Access Compliance Report

Public Rights-of-Way

(Curb Ramps)

Intersection ID: 53405	Main Street: LUTHER_ST	Cross Street: MORGAN_PARK_DR	Location: W
ADA ID: 74CC1EEBF968	Ramp Type: BlendTrans1	Initial Pass/Fail: Pass	Overall Compliance: No
Severity Score: 0			
Codes/Mitigation Info/Possible Solution		Field Measurements/Component Compliance

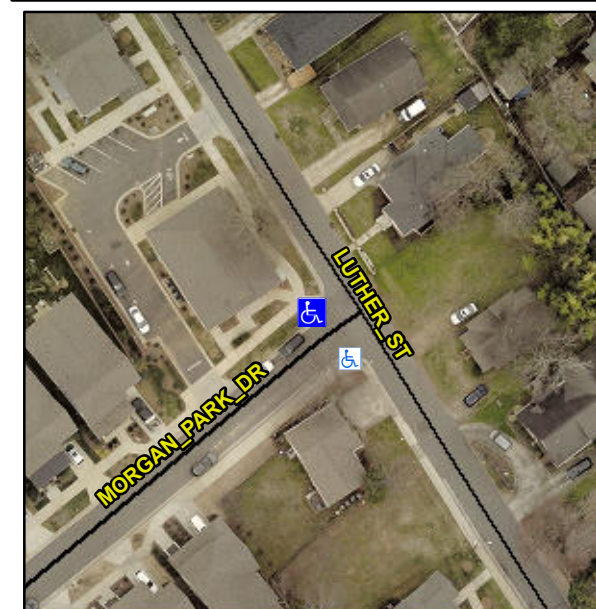
Remove & Replace Detectable Warning System.

R305.2
